**CITY OF ROCKVILLE HISTORIC DISTRICT COMMISSION  
STAFF REPORT  
for  
December 17, 2009  
MEETING NO. 11-09**

**APPLICATION:** HDC2010-00486  
**ADDRESS:** 401 S. Horners Lane  
Pump House  
**ACCEPTED:** 11/23/09  
**45 DAY LIMIT:** 1/15/2010  
**OWNER:** Mayor and Council  
City of Rockville  
**REQUEST:** Approve exterior alterations, with  
Conditions  
**STAFF:** Robin D. Ziek

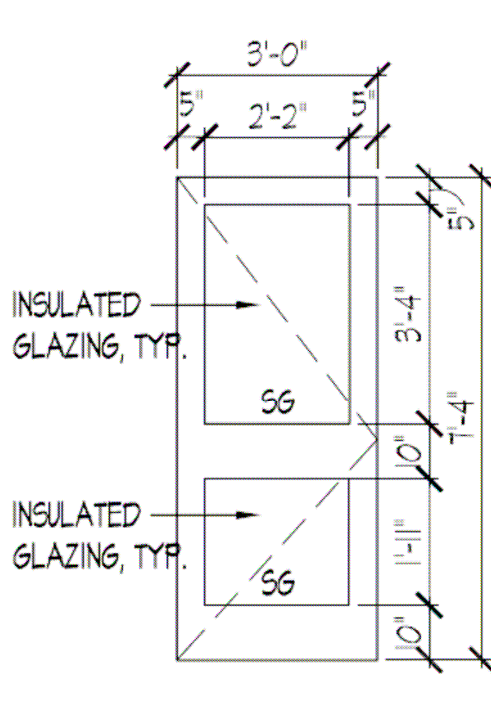
Interior modifications, including the removal of an existing dropped ceiling, will permit the City to reveal the windows in their original size and configuration. The original openings are apparent with extant lintels and modifications to the brickwork, which can be seen on the exterior. There is only one original window remaining in the building, at the attic level on the rear (west) elevation. This 2/2 serves as a model for the new windows, but cannot be retained in place because of the proposed installation of a fresh air louver to serve the new HVAC system. Use of this opening for fresh air intake means that no new opening will be required through the brick load-bearing walls. The window should, however, be retained on site, or perhaps donated to a preservation group for archiving.

The new windows are proposed to be 2/2 design, and aluminum-clad thermally-glazed wood material. The new windows will be of substantial size, and the wood substrate has the structural strength to maintain the maximum glazing area. The proposed use of cladding on the exterior (with wood on the interior) will help allow the City to budget maintenance (wood repair and painting) of original wood materials, including soffits, fascia boards, and window trim (see Circle 26-27, 44).

The Technical Guide #3, Doors and Windows (see Circle 11-13), discusses the policy to retain original doors and windows. As these have already been removed from the site, the Tech Guide recognizes the use of thermally-glazed true-divided-light windows as a suitable replacement. "Wood is the preferred material" and the proposed replacement windows are wood, albeit aluminum clad on the exterior. The Secretary of the Interior's Standard #6 notes that new work may not match original materials: *"Deteriorated historic features shall be repaired rather than replaced. Where replacement is warranted, the new feature shall match the old in, ... where possible, materials."*

*#1 Proposed metal door with large glazed panels*

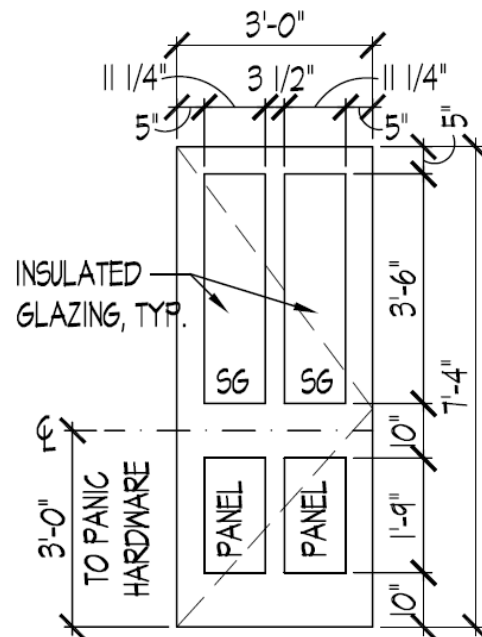
This proposed modern doorway is an interpretation of a typical historic doorway. A quick comparison with other waterworks buildings (the Fairmount Water Works – 1822; Hooton (England) Waterworks – c1890; Tallahassee Waterworks – 1889 see Circle 28-30) indicates that elaborate doors, glazed or solid, were used, and they incorporated transoms. Cities were very proud of these structures, which indicated a commitment to the future and an eagerness to

Staff thanks the architect for providing options for HDC consideration. The solid front door is more typical, certainly, in residential use. The HDC should evaluate this part of the project in light of the public use of the building.

The other three doorways have a secondary function. The door on the north side (existing) is required for egress from the main meeting room. The doorway on the west side closest to the parking lot (existing) is also required for egress from the smaller meeting room/kitchen. The new rear door on the west façade is proposed in order to provide access to the new HVAC equipment, which is being installed in the non-original concrete block addition to the Pump House.<sup>1</sup> The doors will be hollow-core metal doors, either painted or with factory finish. The panelized door, however, is more compatible with Victorian design than a modern flush door, and staff recommends this design for the secondary doorways.

East elevation  
door

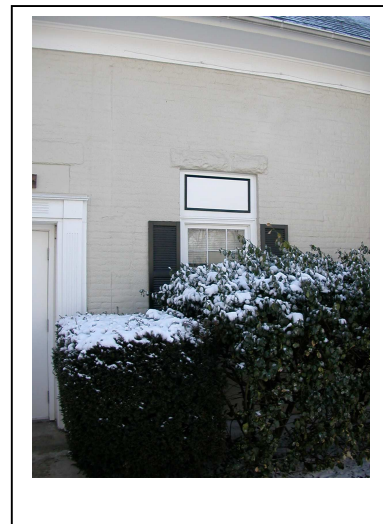
The mature shrubs around the Pump House are proposed to be removed, including the shrubs along S. Horners Lane that hide the front (east) elevation of the building and block the front windows as well. Corner evergreens will also be removed. All of this plant material is too close to the building and prevents adequate ventilation of the exterior bricks. In addition, the removal of the plant material will reveal the building to view, and staff urges the HDC to approve the removal of this existing plant material.

The project will include some modest grading to accommodate ADA at the north side and west rear elevations. Concrete slabs that will be ADA compliant will be installed at each (3) of the exterior doors: two on the west elevation and one on the north elevation. In addition, the walkway at the front entrance will also be modified to comply with ADA. All of this work is essentially at grade, and there is no need for ramps or other exterior structures to provide ADA accommodation.

The City plans to work with the community at a future date to develop a landscape plan. This shall be presented to the HDC prior to moving forward with implementation. In addition, it may be useful to include a representative of the HDC on the community landscape group.
